AppSer. No. 09/854,172

AUTO-ADJUST NOISE CANCELING MICROPHONE WITH  
POSITION SENSOR  
Inventors: Robert J. Bernardi, et al.

Reply to Office Action of July 9, 2008  
Annotated Sheet showing changes

FIG. 1

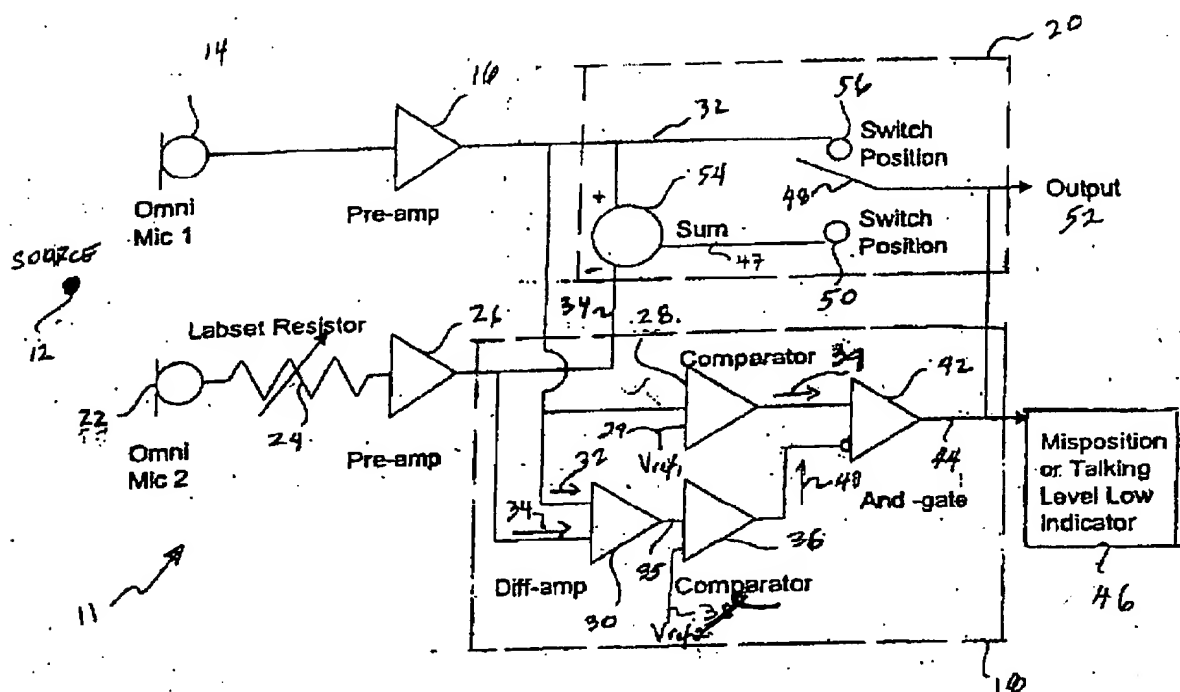
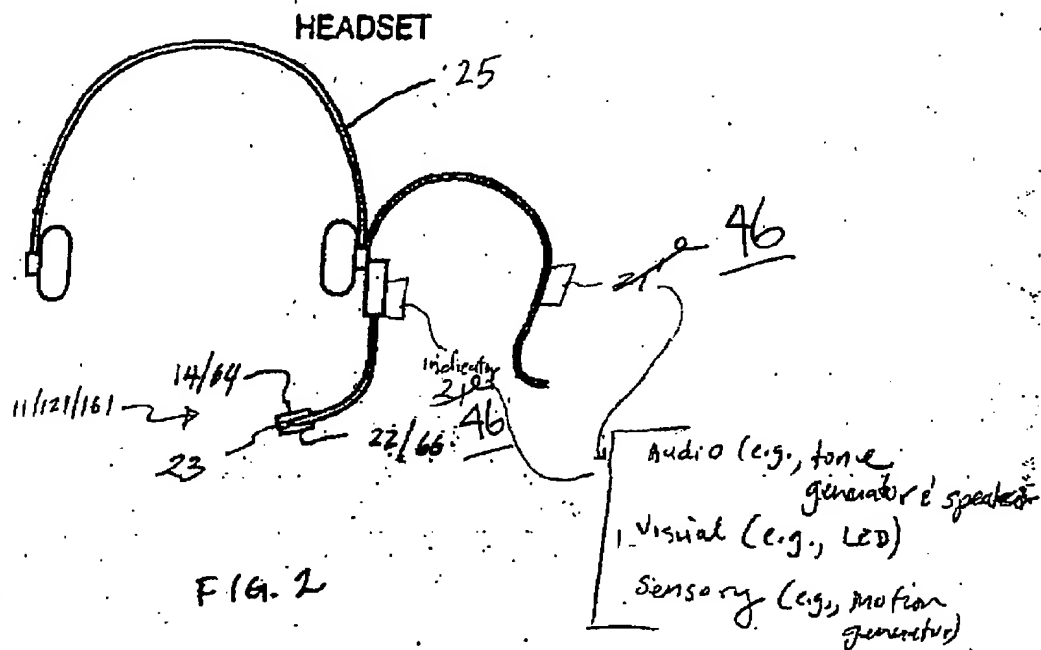
Some minor errors are also corrected in FIGS. 1-3. In particular, in FIG. 1, reference number 38 is removed as the specification does not contain reference to 38.
